# Roof Extension

## East Elevation

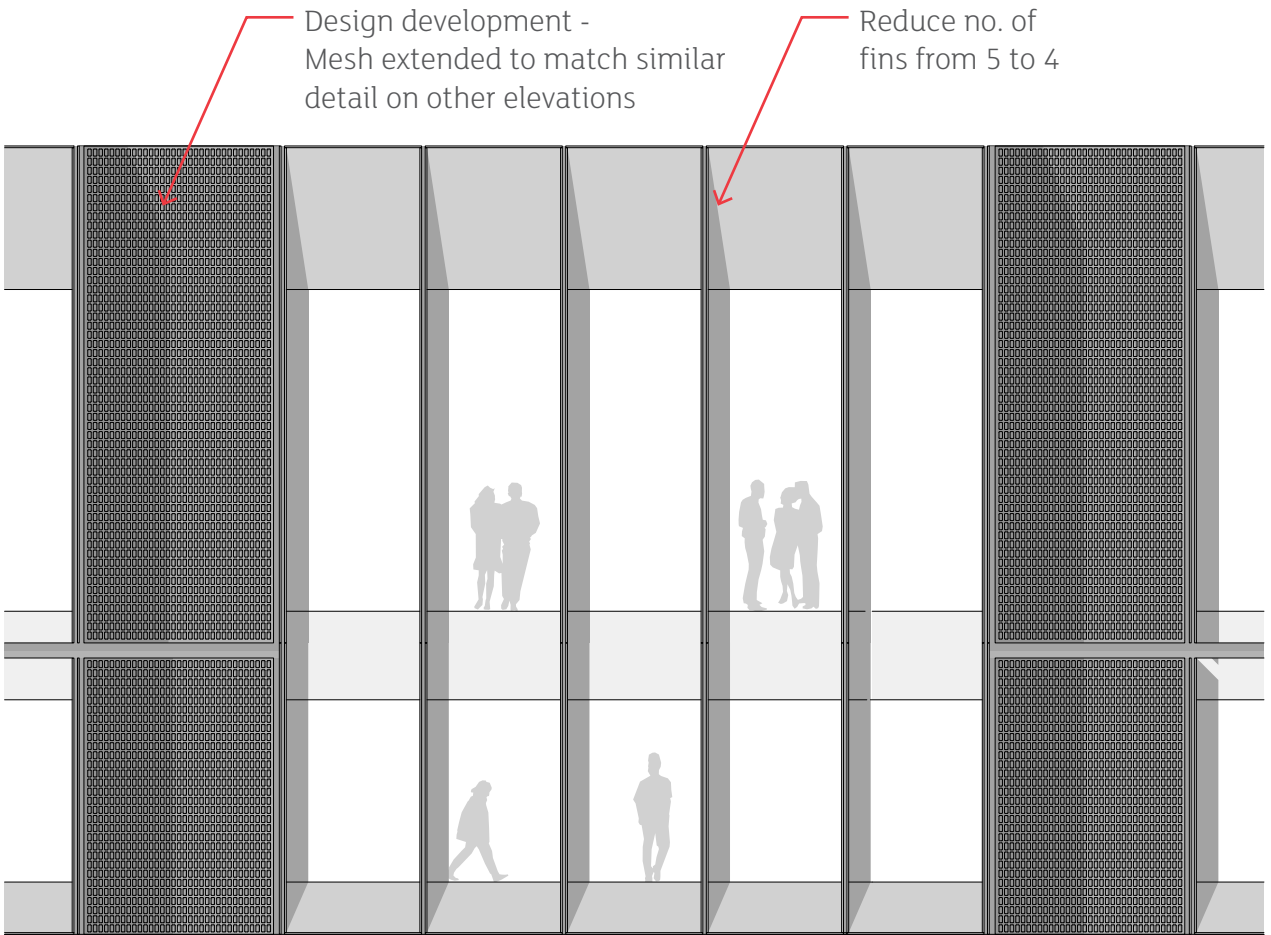
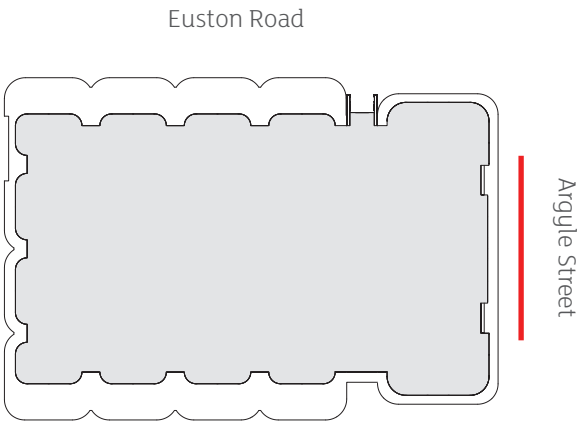
The central bay to the east facade (9th and 10th floors) previously consisted of 6 glazed panels with 5 intermediate fins. The revised proposal now has 5 slightly wider glass panels with 4 intermediate fins to better match the proportions of the other bays and afford better views out of the building.

Reduce depth of fins on centre bay only to match north and south facade. Corner bays on east facade to retain deeper fins
